Access Compliance Report Public Rights-of-Way (Curb Ramps)

Intersection ID: 6582 Main Street: LIGON CT **Cross Street: PAMELA LORRAINE DR** Location: ADA ID: DCAA5BD0A9E7 Ramp Type: BlendTrans1 Initial Pass/Fail: Fail **Overall Compliance: No Severity Score:** 12.5

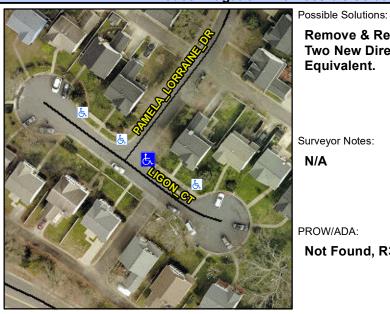
Not Found, R304.5.3

Field Measurements/Component Compliance					
Compliance Description		Data	Compl	iance Description	Data
N/A	Ramp Length (in)	73.0	Yes	BlendTrans Slope (%)	2.1
Yes	Ramp Width (in)	48.0	No	BlendTrans XSlope (%)	6.2
N/A	Flare Type LT	N/A	N/A	Flare Type RT	N/A
N/A	Flare Slope LT (%)	N/A	N/A	Flare Slope RT (%)	N/A
N/A	Flare Traversable LT?	N/A	N/A	Flare Traversable RT?	N/A
N/A	Landing Length (in)	N/A	N/A	DWS Provided?	N/A
N/A	Landing Width (in)	N/A	N/A	DWS Contrast?	N/A
N/A	Landing Slope (%)	N/A	N/A	DWS Length (in)	N/A
N/A	Landing X Slope (%)	N/A	N/A	DWS Full Width?	N/A
N/A	Landing Curb? (Y/N)	N/A	N/A	DWS Offset (in)	N/A
N/A	Shared Landing?	N/A			
N/A	Gutter Ponding?	N/A	N/A	Gutter Slope (%)	N/A
N/A	Gutter Lip Ht (in)	N/A	N/A	Gutter X Slope (%)	N/A
N/A	Painted X Walk1?	No	N/A	Painted X Walk2?	N/A
	X Walk 1 Direction	To N		X Walk 2 Direction	N/A
	X Walk 1 Width (in)	N/A		X Walk 2 Width (in)	N/A
	X Walk 1 Slope (%)	2.2		X Walk 2 Slope (%)	N/A

X Walk 1 X Slope (%)	1.5		X Walk 2 X Slope (%)	N/A
N/A	Ramp inside XWalk1?	N/A	N/A	Ramp inside XWalk2?	N/A
	Road Slope (%)	1.5		Clear Space?	N/A
	Road X Slope (%)	2.2	N/A	Clear Space to XWalk (in)	N/A
N/A	Any Obstructions?	N/A	N/A	Storm Grate/Utility Hazard?	N/A
	Obstruction Type			Storm Grate/Utility Type	
		N/A			N/A
			Yes	Surface Condition? (G/P)	Good
	Minimularia sa		No	Curb Slope (%)	12.9

PAMELA LORRAINE DR Street 1 Name Stop Condition-Street 1 StopSign Street 2 Name N/A Stop Condition-Street 2 N/A Remove & Replace Curb Ramp With Two New Directional Ramps or Equivalent.
